Service Bulletin

Product Update

SUB-C200229

Product Update: Steam Valve

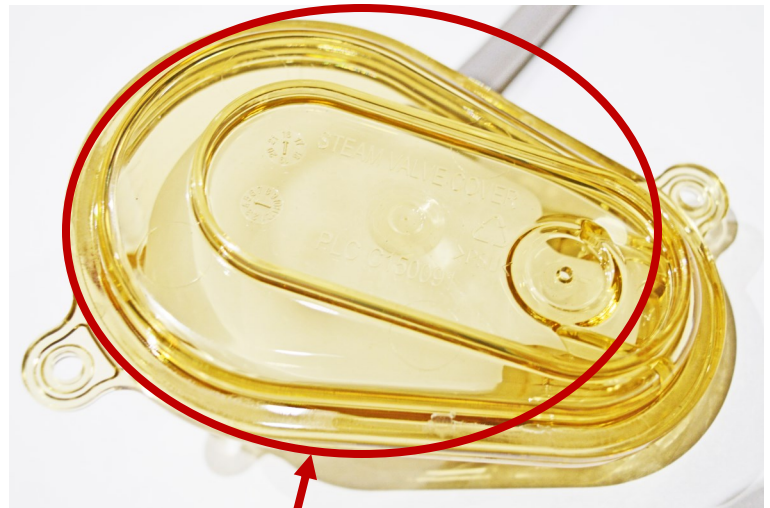
As part of our dedication to continuously improve our product, Crystal Mountain has changed the construction of the Steam Valve used in the Storm, bottom load, water cooler. Previously the steam valve had a circular, sealed float which was used to close the steam vent opening during usage. The circular float has been replaced with a “D” or oval shaped float which is bottomless. The previous float was the same clear, amber colored plastic as the steam valve body while the new design uses a white plastic float body.

All new production will use the updated steam valves once the older parts are used up by production. The same will hold true for spare parts. All orders will be fulfilled using the new parts once stock is depleted. A new part number will be utilized at that time.
